**Lindfield Learning Village**

Traffic and Transport Assessment -  
SEARs Comment Response

Issue | 20 November 2017

Drawing Title  
 Turning Paths  
 For Bushfire Cat 1 Tanker

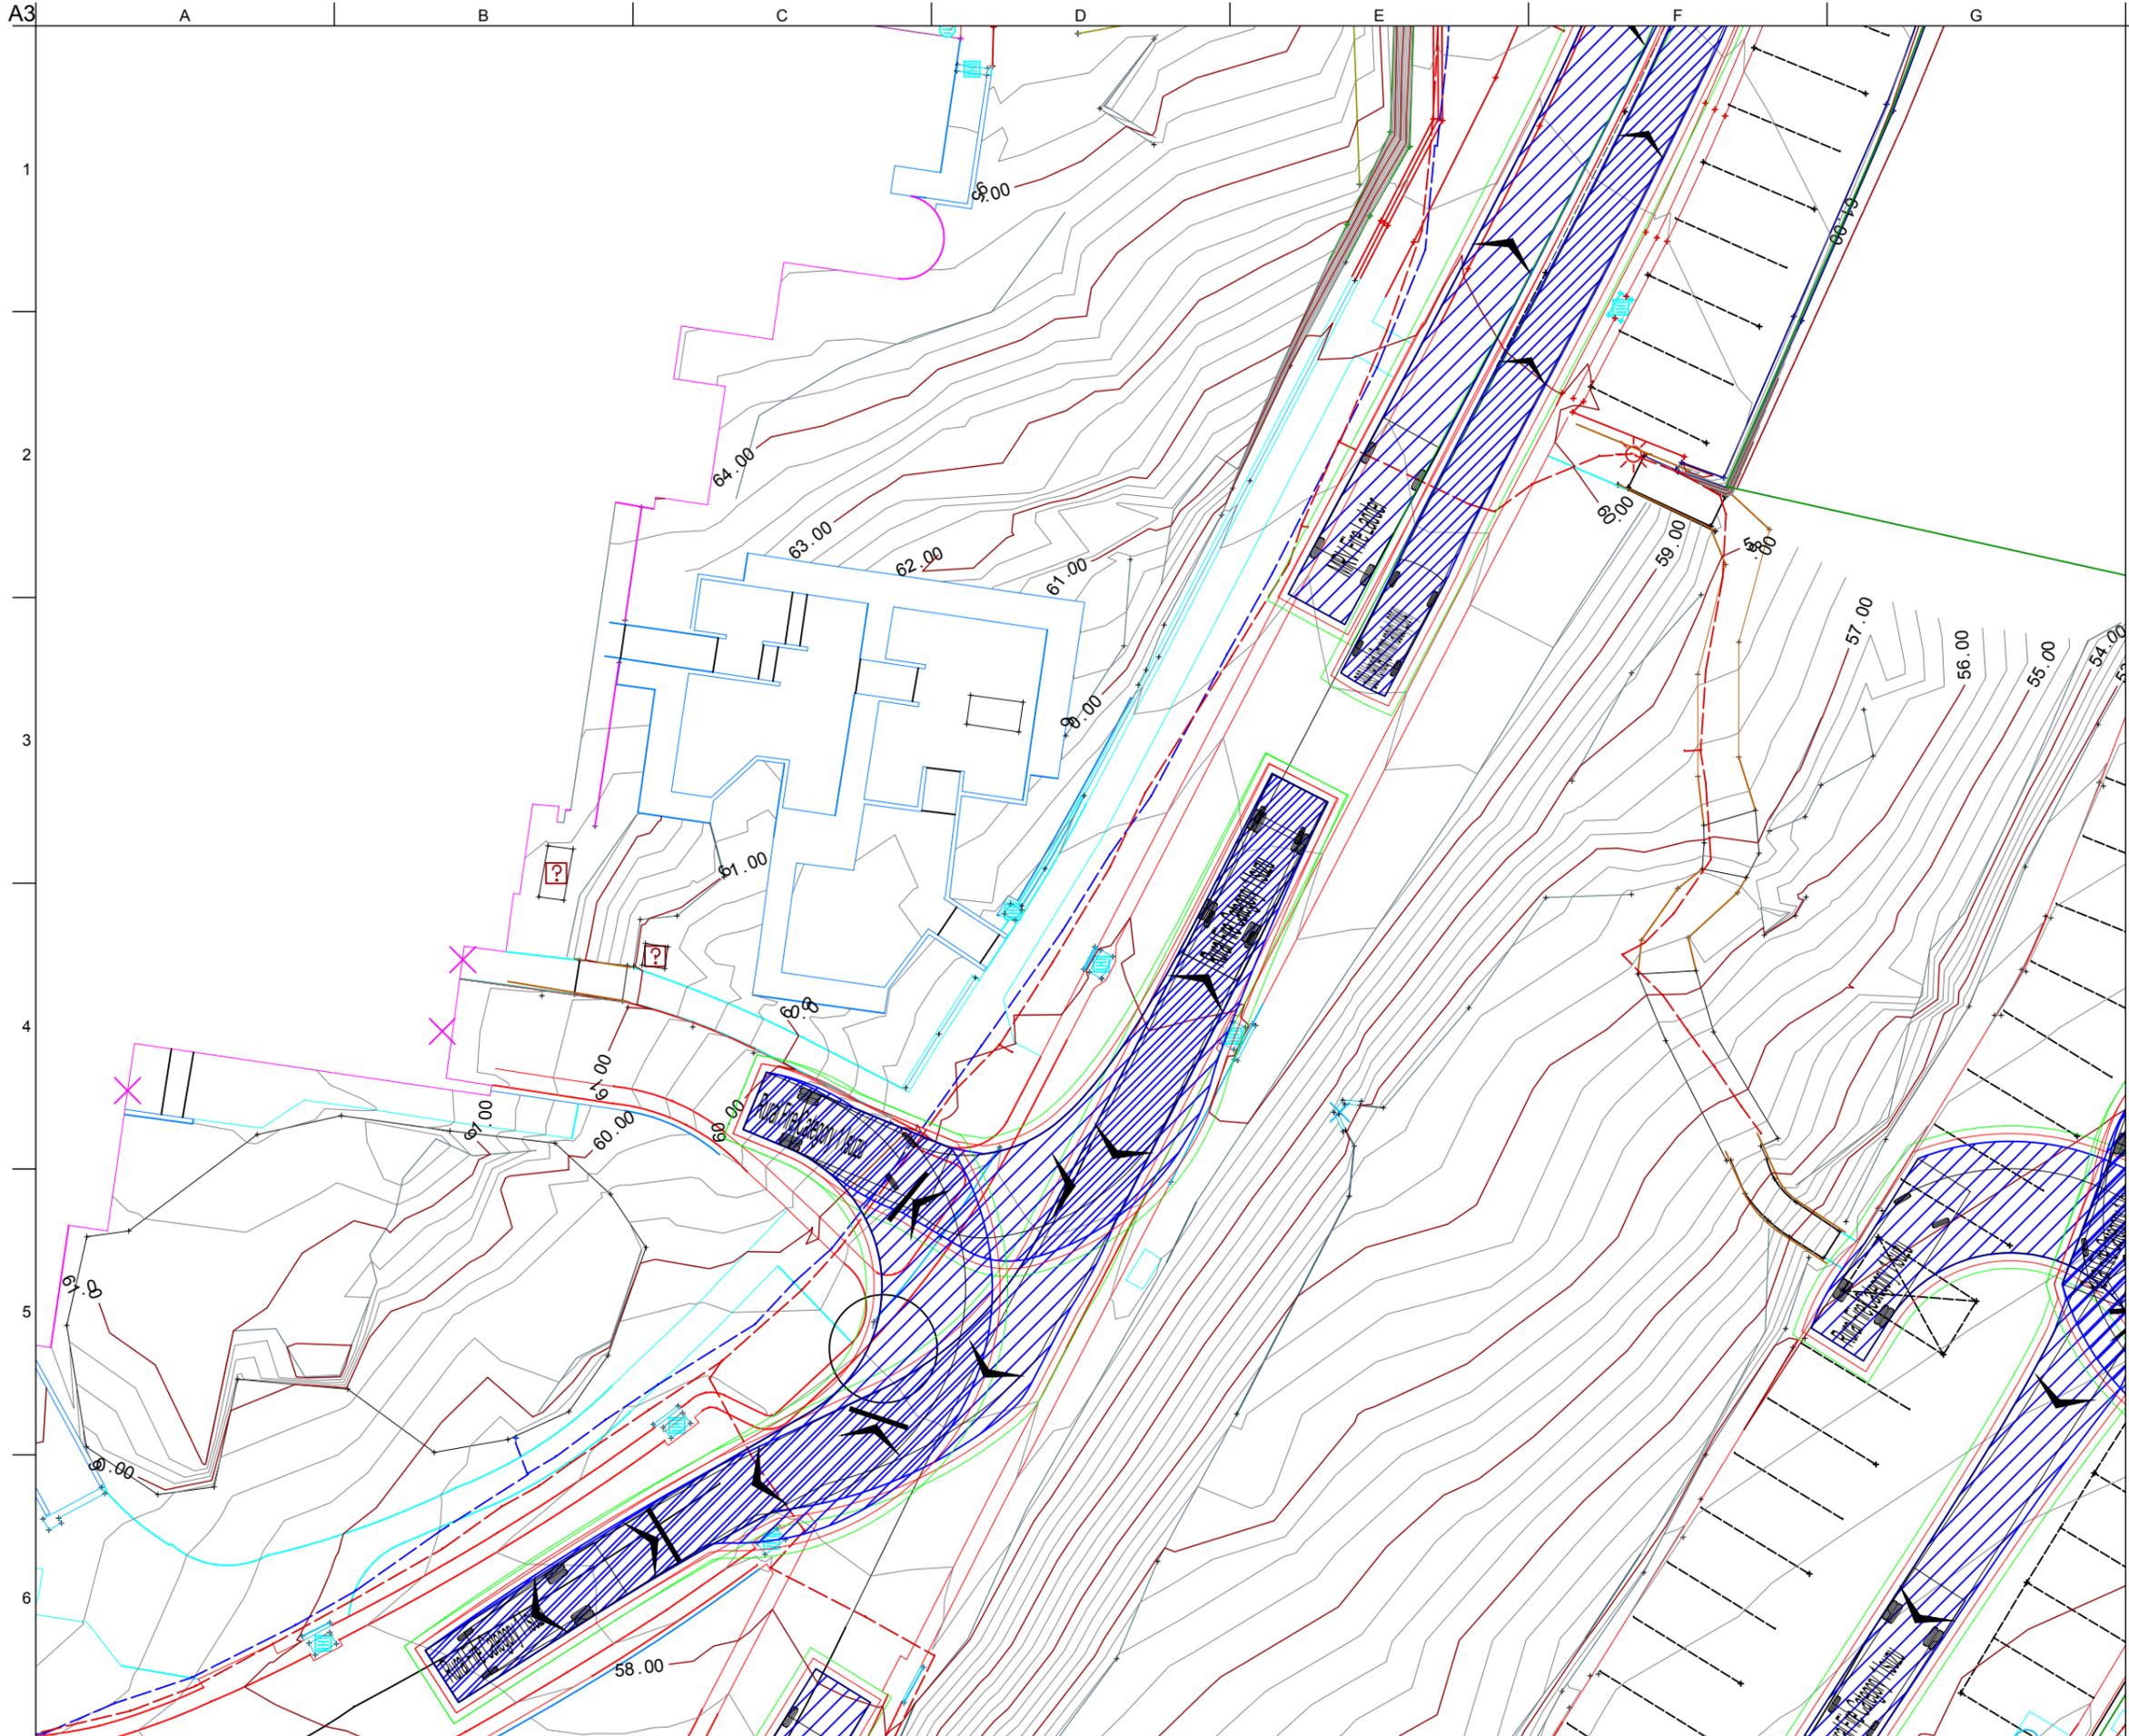
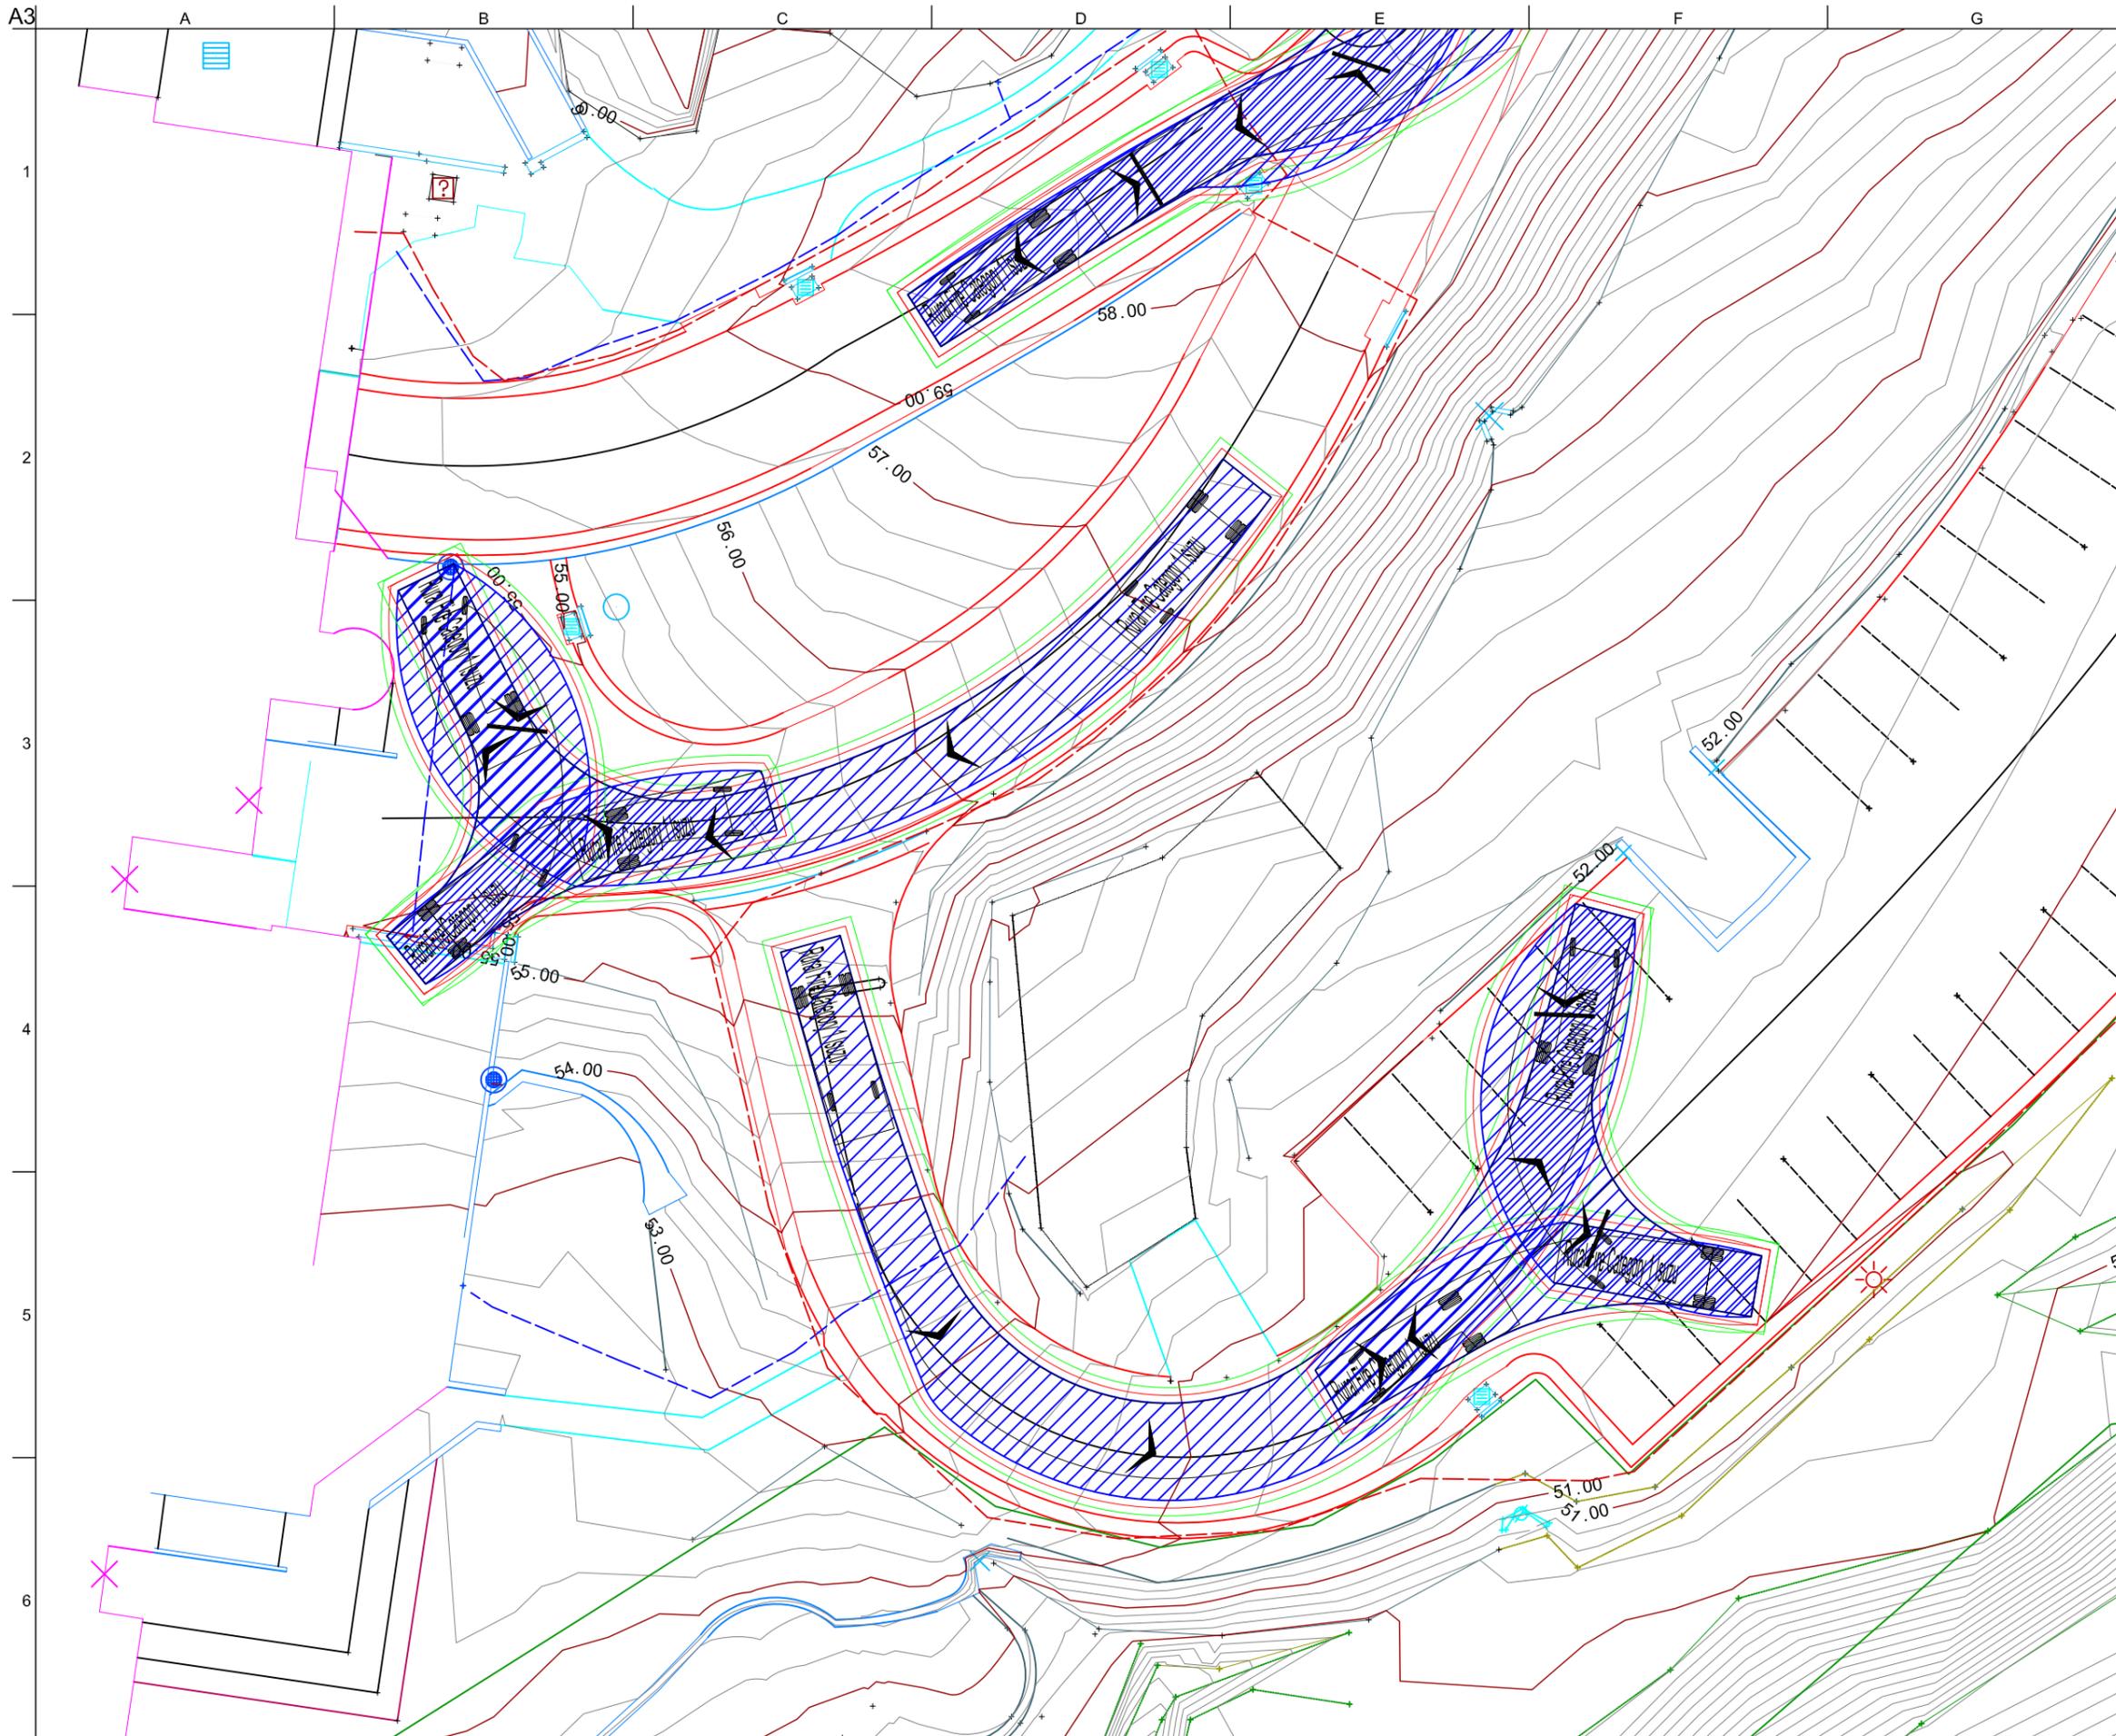
R#	Comment	Arup response
R1	[1] Given the narrow nature of the Eton Road access to the campus/school grounds, Roads and Maritime requires clarification regarding emergency vehicle access in emergencies.	Discussed in section 2.1
R2	[2] The existing bus bay/turnaround facility has inadequate holding capacity for the proposal as the proposed bus volumes will queue out onto Eton Road. Roads and Maritime does not consider the proposed bus bay appropriate for the following reasons:	The number of buses accessing the bus bay at any one time will be limited to its holding capacity.
R3	[2.1] The bus bay rank arrangement only allows for buses to arrive in a specific order to access their specific route rank. If buses arrive out of order, heavy delays will result from buses having to queue outside the bus bay. There are no opportunities available for buses to leap frog each other to get into the correct order before proceeding into the bus bay.	<p>Buses will not need to arrive in any specific order. The proposal shown in Section 2.2 allows enough pedestrian area for students to proceed to the correct bus when it arrives. Buses will be scheduled to arrive ahead of the pick-up time. Buses will therefore wait in order and depart at the same time.</p> <p>The proposed design looks at an arrangement where pedestrians walk on a 3m wide footpath around the bus bays This results widening of the bus roadway into the central void space to allow for bus turning.</p> <p>It was agreed that buses would not be able to leap frog past each other. The proposed arrangement would have buses waiting for children, negating the need for leap frogging. It was agreed that fencing would be provided for the safety of students as well as the possibility of a gate system at the pedestrian boarding locations. It was agreed that these access points need to be monitored and managed by traffic wardens / teachers.</p> <p>DPE advised that the bus bay could be dealt with as a condition of consent. The design requires formal approval from Council, TfNSW and RMS, and would need to include a detailed design and a detailed explanation of how students would board the buses. Safety is paramount.</p>

Emergency vehicle swept paths have been carried out for different areas of the site using MRV Fire Ladder 7.8 metre truck or a CAT 1 Tanker. The swept path analysis has indicated multiple opportunities for the truck to turnaround efficiently, shown in Appendix A.
